RE: Response Letter –Township Traffic Review Letter

Westtown School Oak Lane Project
Westtown Township, Chester County
TPD Job #WESC.00003

Re: Westtown School Oak Lane Project - Traffic Review
Westtown Township, Chester County

DATE: 10/16/23	PROJECT DESIGNER: TAM	JOB NO: WESC.00003
SIGHT DISTANCE DIAGRAM - EXHIBIT A		
THIS IS A COPY. THE ORIGINAL DRAWING IS ON FILE WITH TRAFFIC PLANNING AND DESIGN, INC. ANY AND ALL LIABILITY IS LIMITED TO THE ORIGINAL, UP TO AND INCLUDING THE LAST REVISIONS.

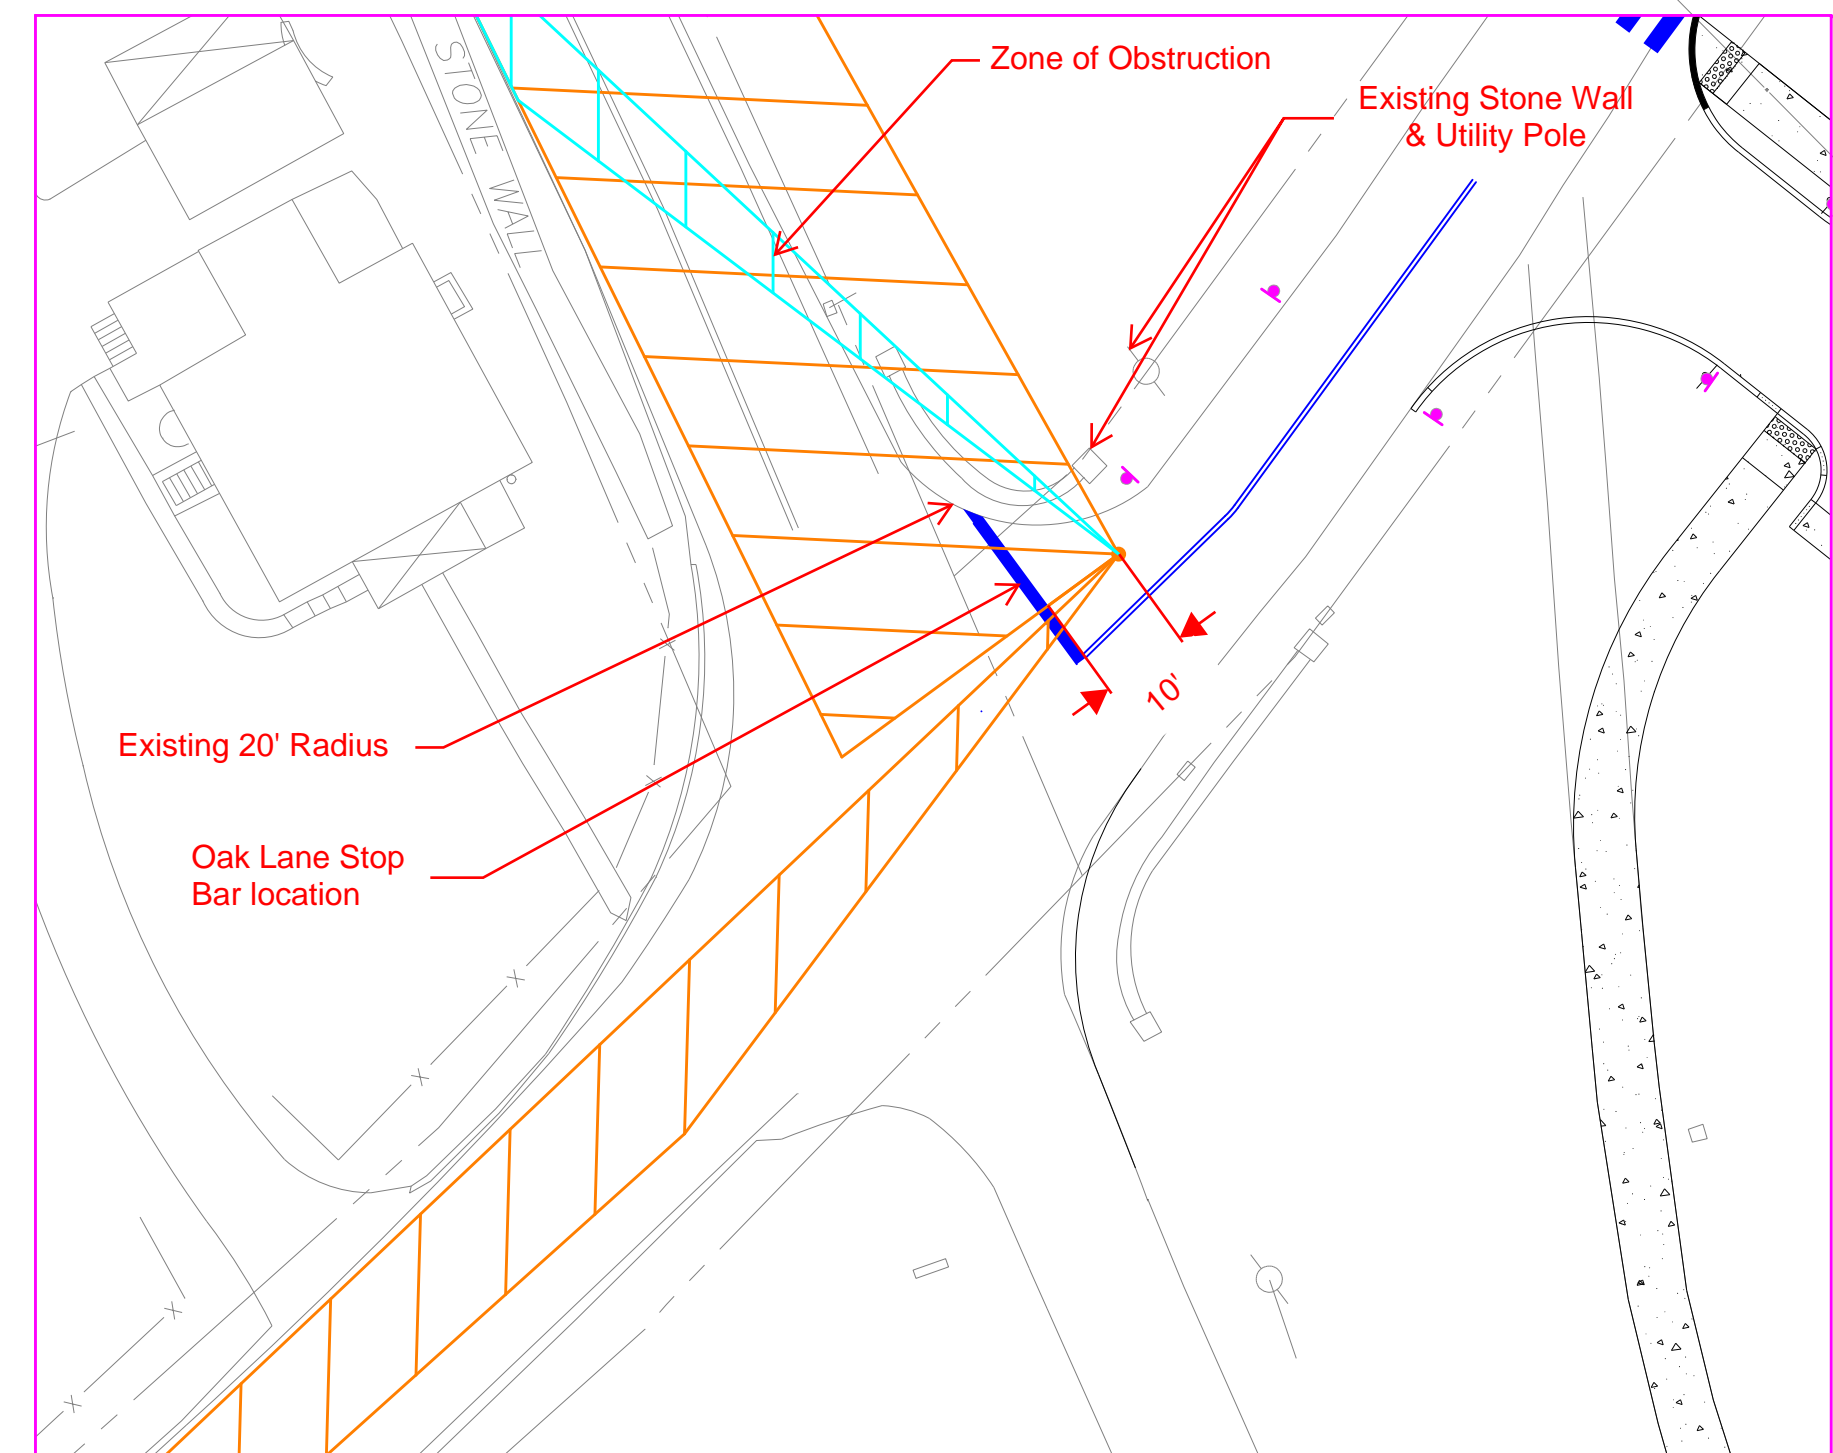
6. As previously noted, a minimum 35-foot radius curb return should be provided for Oak Lane at Westtown Road. {§149-907F}. The Applicant has indicated that a Waiver will be requested. Additional information demonstrating how the literal compliance is unreasonable, would cause undue hardship, or the alternative standard providing equal or better results.

As illustrated in Exhibits A and B, there is no tangible benefit to improving sight distance by relocating the existing wall as a result of installing a 35' foot radius per the ordinance (location and shape of relocated wall in Exhibit B for illustrative purposes only).
